College Brook Degradation & Flooding:

20 Years of Mill Plaza Violations* & Deceptions

Submitted to the Durham Planning Board, Conservation Commission, & Town Council, January 4, 2022

by Joshua Meyrowitz, 7 Chesley Drive, Durham, NH

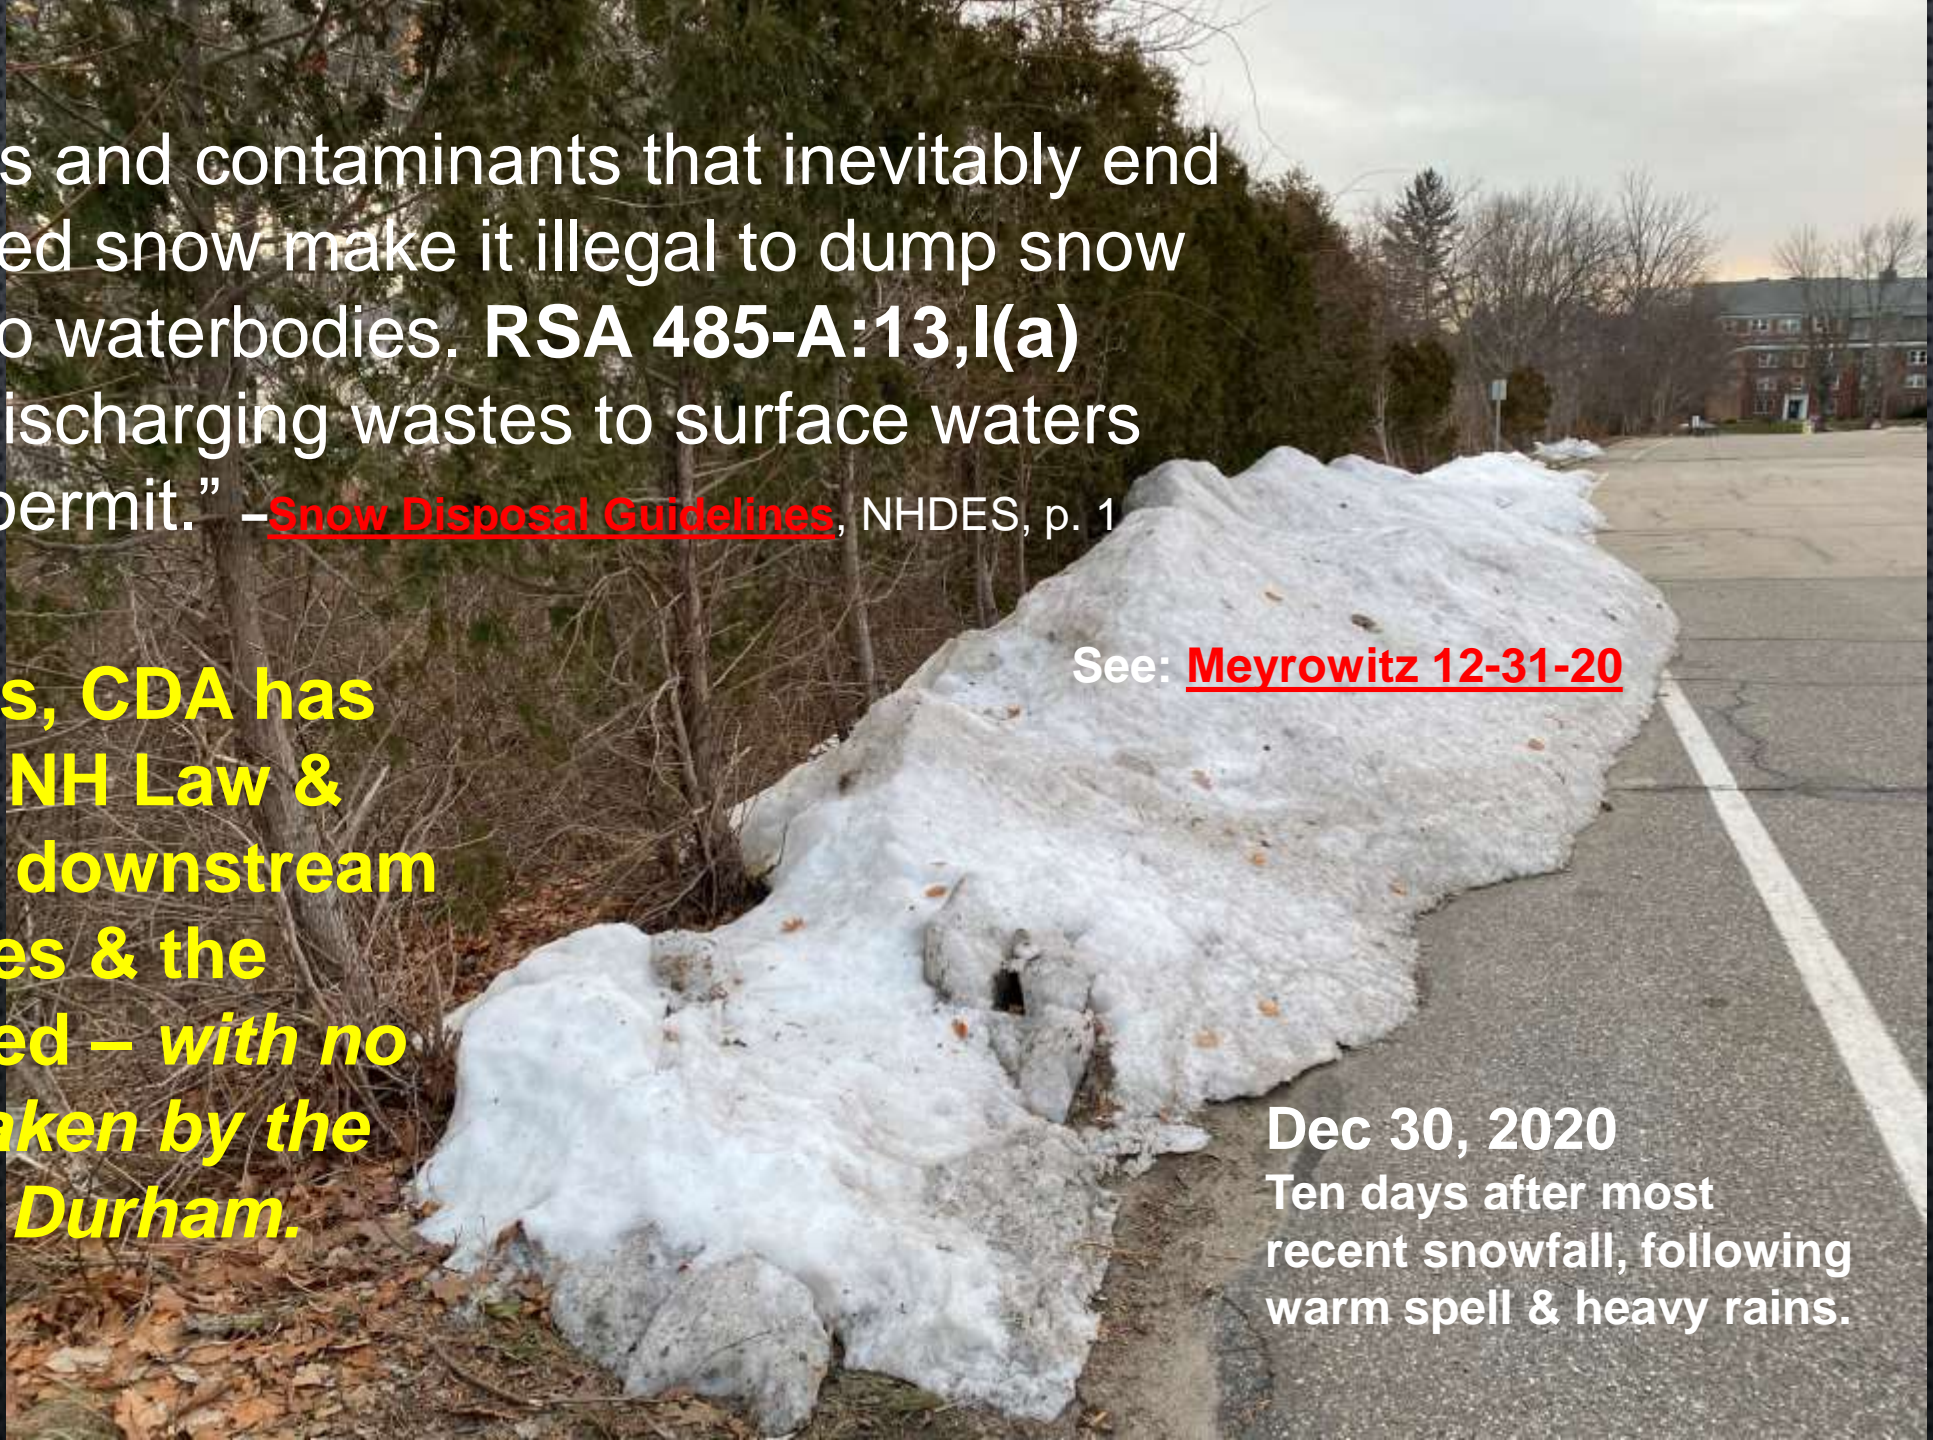
The CDA project, while it has many positive elements for stormwater management, has some significant deficiencies for both the lack of buffer restoration as it relates to stormwater management, and for nonconformance with the 75-foot wetland buffer.

The plan presented is notable for an obvious missed opportunity for nitrogen reduction through a restored wetland buffer and stream restoration, both of which are important stormwater BMPs. Nitrogen reduction from stormwater and nonpoint sources is an essential requirement for the new EPA Total Nitrogen General Permit to avoid more stringent wastewater limits.

The proposed significant changes of an existing non-conforming site require compliance with buffer setbacks.... Finally, it is important to recognize that **any CDA project shortcomings for nitrogen controls will be paid for by the Town of Durham in future efforts in fulfillment of nitrogen reduction required under the new Total Nitrogen General Permit.**

For these reasons, I believe that the project application is **deficient and requires substantial changes for permitting compliance.** (emphasis added)

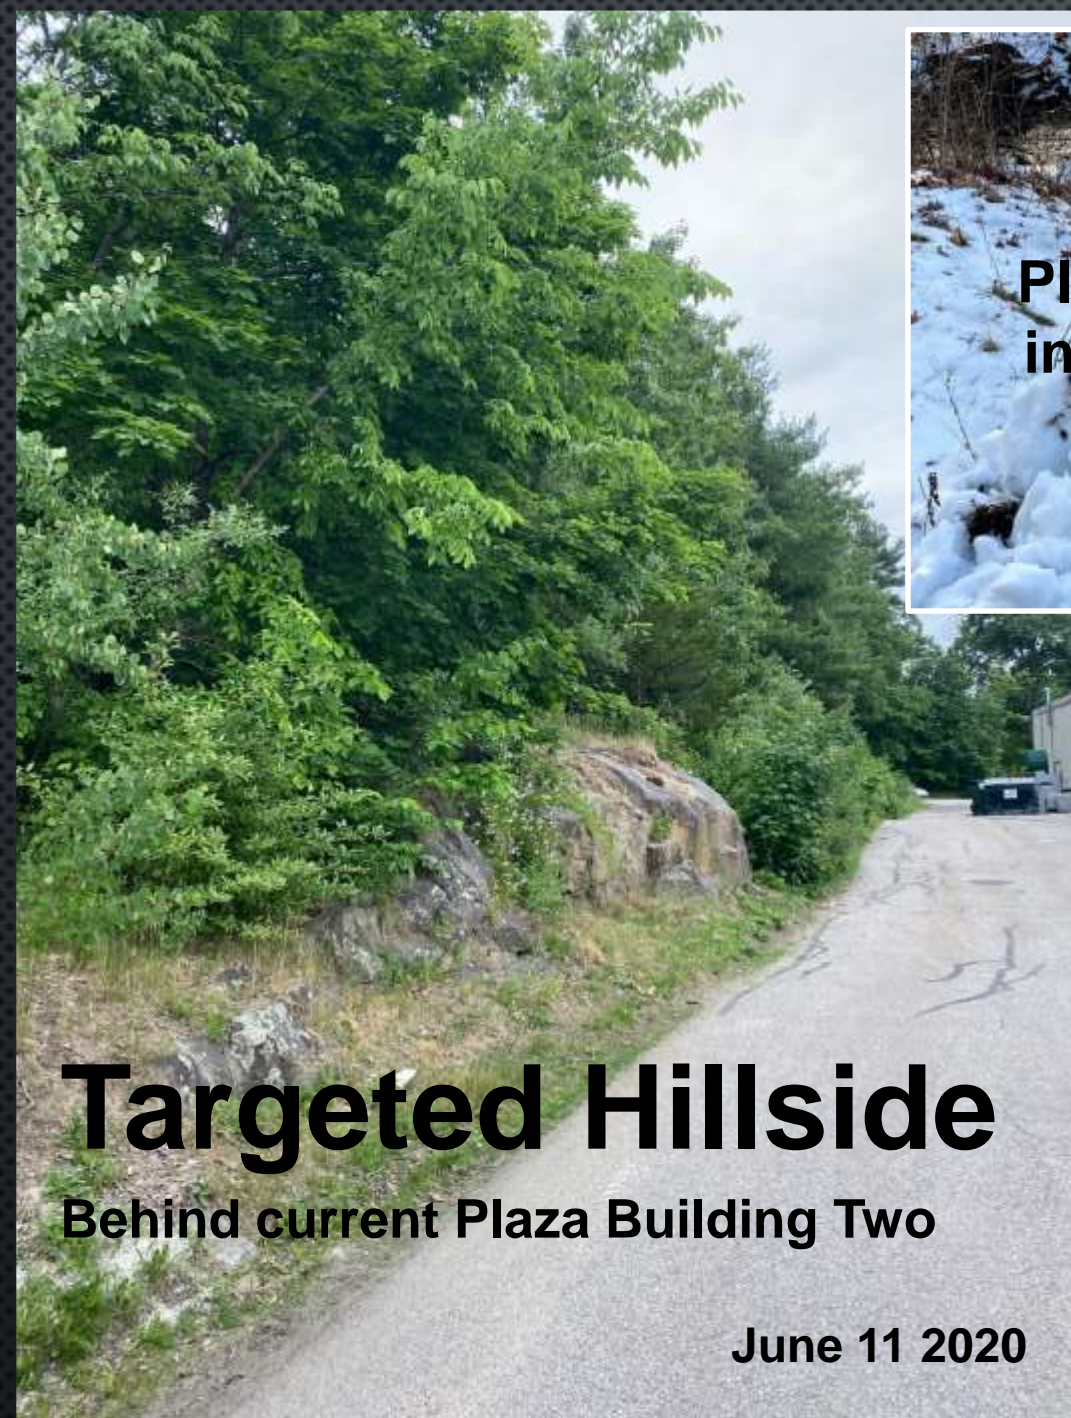
Most of the College Brook watershed is upstream of Mill Plaza, yet the Mill Plaza is unique in scale/density of impervious surfaces directly along & draining into brook

1.1-acre vegetated Plaza hillside to be blasted away to fit in new buildings

Steeply sloped (into flood zone) Church Hill Woods (separate owners) to become Plaza-tenant parking

Indeed, CDA's current proposal overall (with Plaza hillside & Church Hill Woods demolitions) would *increase* scale & density of impervious surfaces upland of the College Brook flood zone.
